CITY OF ALBUQUERQUE

RE: Mercado El Milagro - Building D 30-Day Temporary CO - Approved Engineer's Stamp Date: 06/30/22

DRAINAGE AND TRANSPORTATION INFORMATION SHEET (DTIS)

SHEET NO: **CG-101**

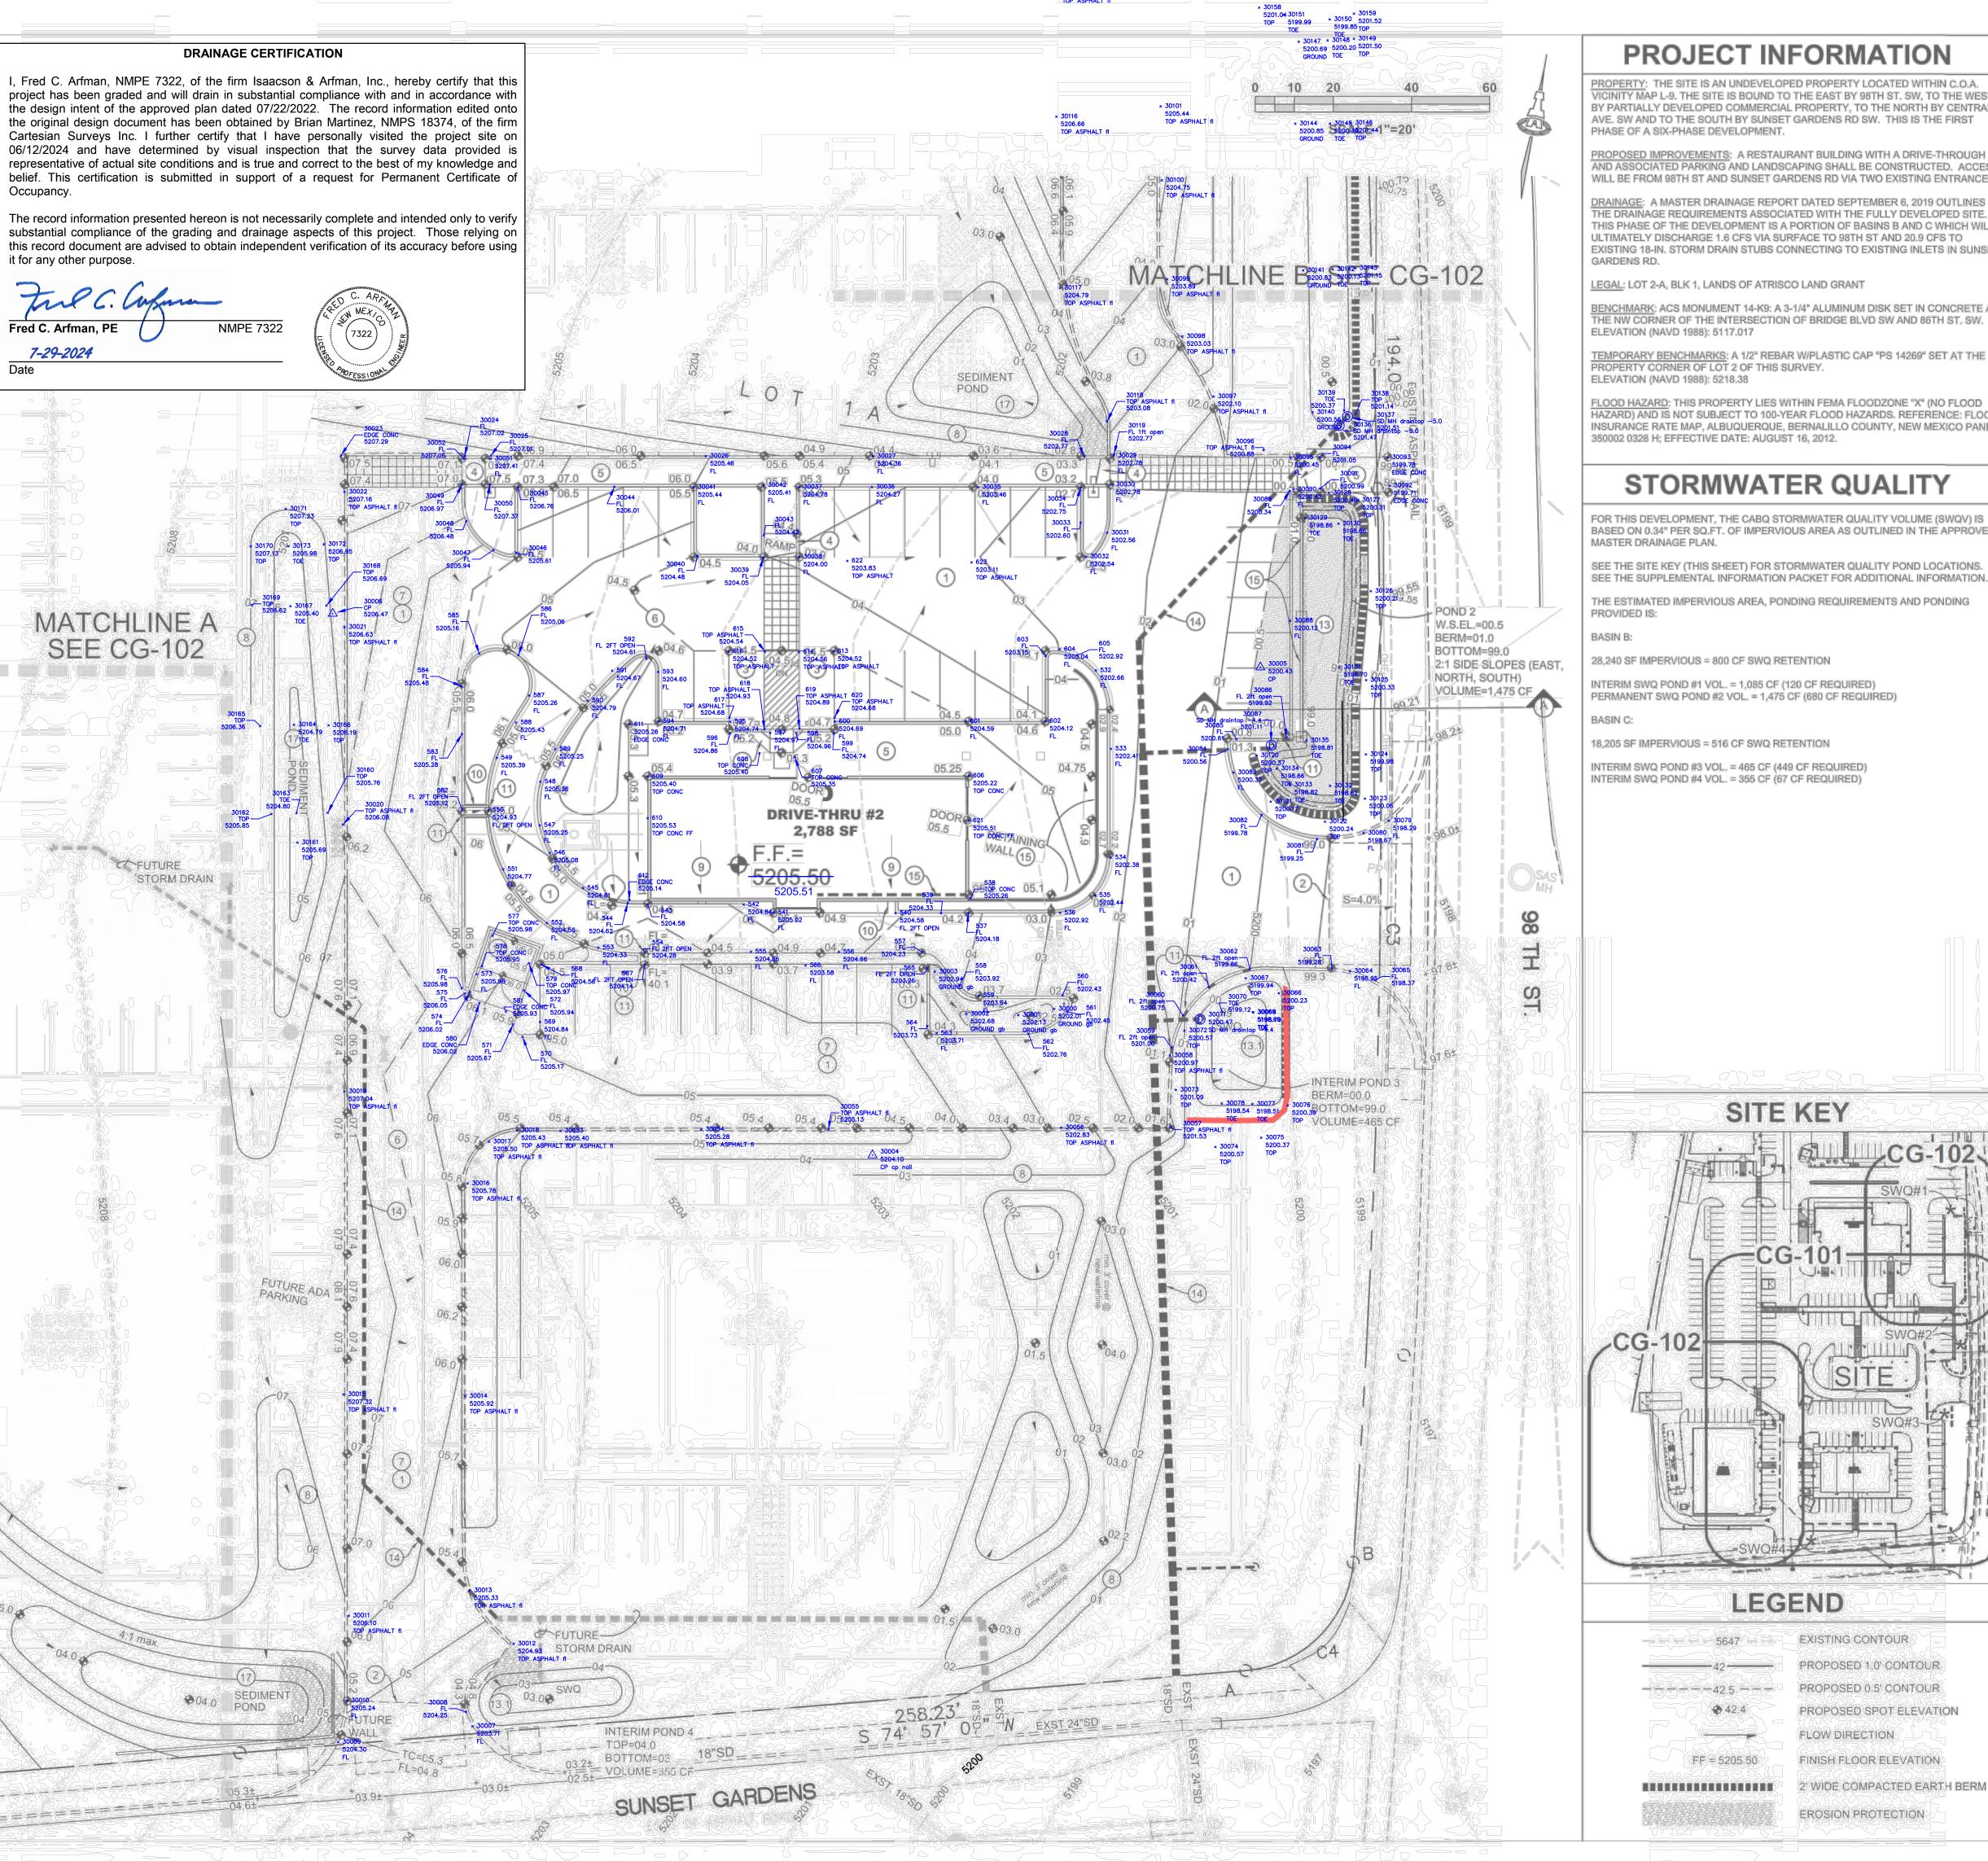
1. Please provide the executed paper Drainage Covenant (latest revision) printed on one-side only with Exhibit A and a check for \$25.00 made out to "Bernalillo County" for the stormwater quality ponds per Article 6-15(C) of the DPM to Hydrology.
